反對錦上路丈量 DD112 Lot 246 862 和毗連政府土地
(申請編號：Y/YL- SK/1)

Y/YL-SK/1

Lots 246, 247 (Part), 251 (Part), 253 (Part), 254, 255 (Part), 256, 257, 258 (Part), 260, 263, 273 RP, 274, 275, 277, 278 S.B, 279, 280, 284, 294 RP, 295, 849, 850, 851 (Part), 853, 856 (Part), 859 (Part), 861 (Part) and 862 in D.D. 112 and Adjoining Government Land, Kam Sheung Road, Shek Kong

Re: Comments to the Town Planning Board in respect of Application Y/YL-SK/1

Figure 2 – Catchment plan served by the proposed boundary channels and pipes for Wah Yuen Area under Proposed Condition

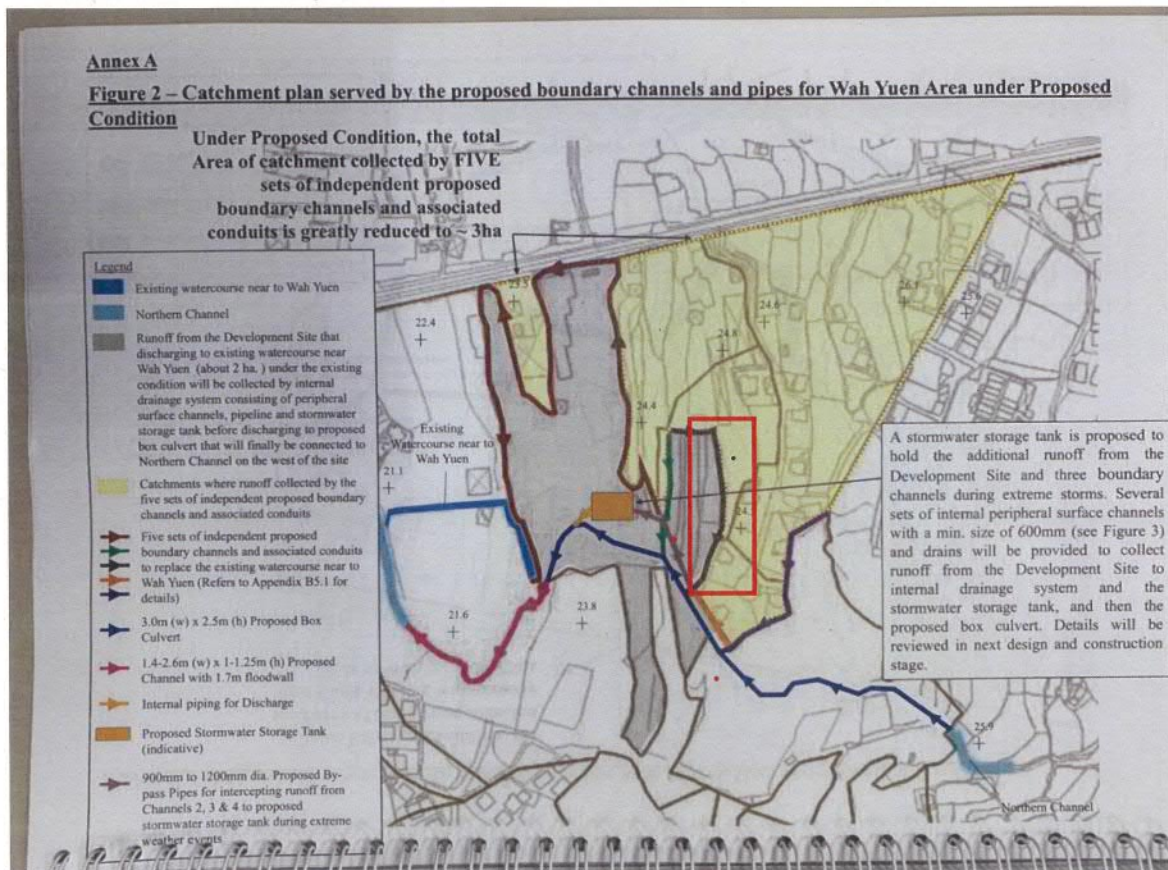
Under Proposed Condition, the total Area of catchment collected by FIVE sets of independent proposed boundary channels and associated conduits is greatly reduced to ~ 3ha

As mentioned all this time in our previous rounds of comments, there is a small stream along the western boundary wall of Wah Yuen. During heavy rain before, the water level of this stream occasionally goes up 1.5m + from the trough of the stream within 1 or 2 hours. In fact this is the original point where previous floodings in Wah Yuen began. It has never been taken into consideration in any of the original proposed development plan nor additional information before.

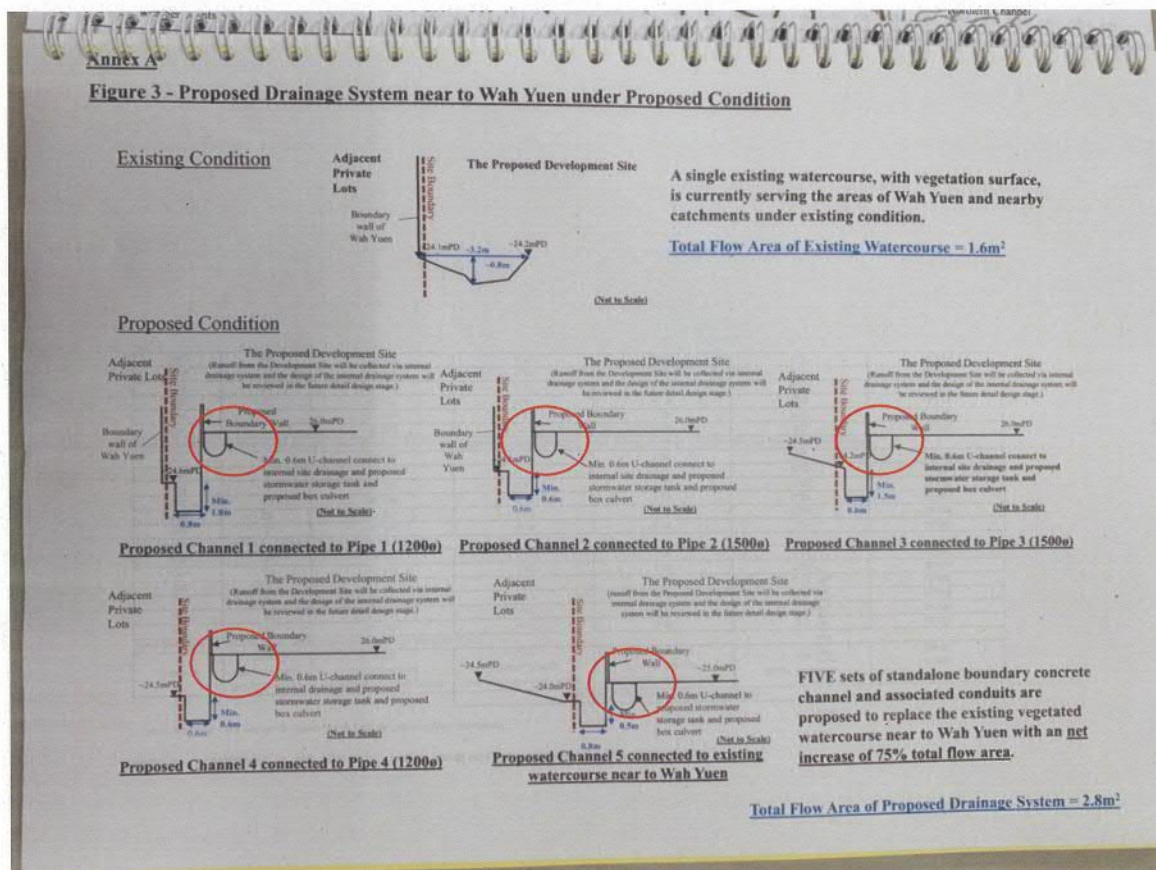
Appendix C1/C2/ – “Existing Channel and Modelled” does NOT include waterstream.

Appendix D2 – “Existing Channels” does NOT include waterstream.

2) Waterstream outside western wall of Wah Yuen IGNORED and IGNORED and IGNORED

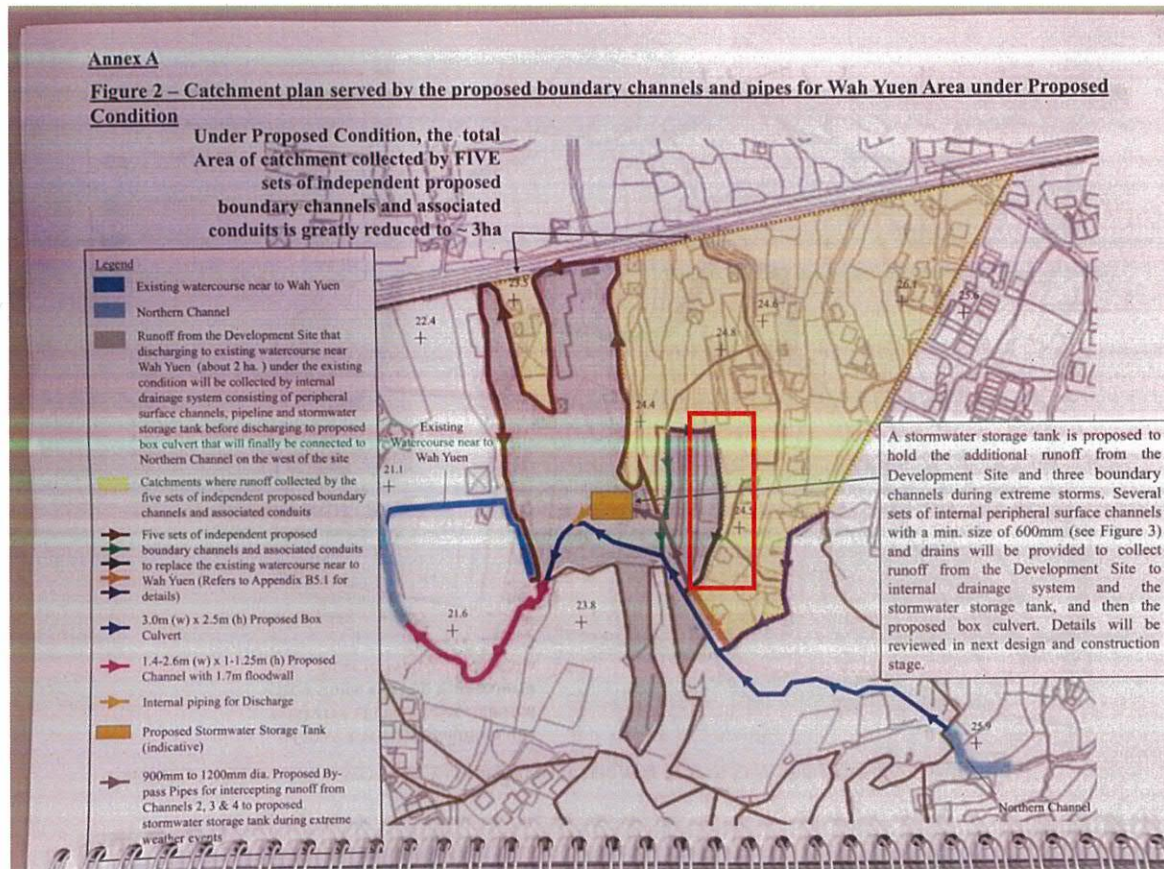
Despite repeatedly expressing our concerns, there is nothing mentioned on how to deal with possible flooding threat to the area on the western side of Wah Yuen (area highlighted in red below).

As mentioned all this time in our previous rounds of comments, there is a small stream along the western boundary wall of Wah Yuen. During heavy rain before, the water level of this stream occasionally goes up 1.5m + from the trough of the stream within 1 or 2 hours. In fact this is the original point where previous floodings in Wah Yuen began. It has never been taken into consideration in any of the original proposed development plan nor additional information before. **On the day of the Black Rain dated 8th September, houses along this western boundary were flooded, as witnessed by the officers from the Drainage Services Department.**

Appendix C1/C2– “Existing Channel and Modelled” does NOT include waterstream.

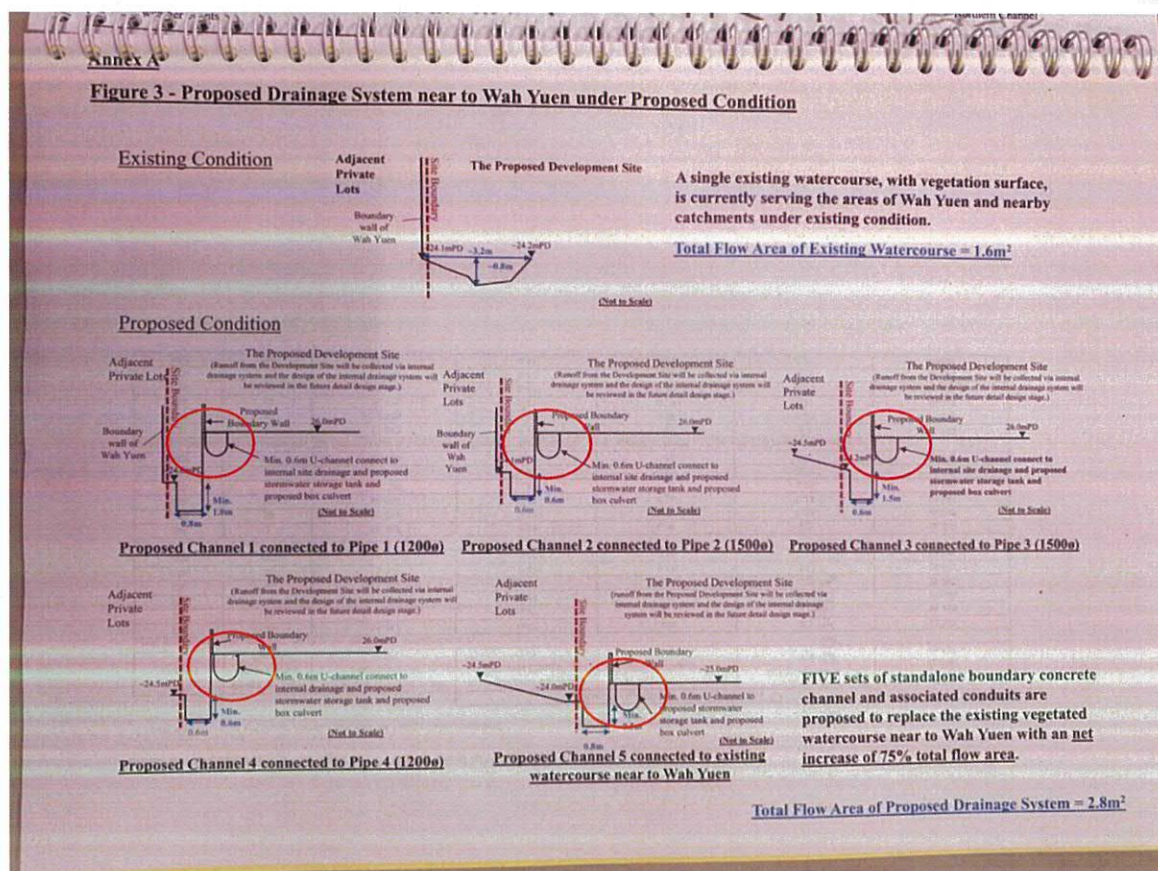
Appendix D1 – “Existing Channels” does NOT include waterstream.

Appendix D2 – “Existing Channels” does NOT include waterstream.
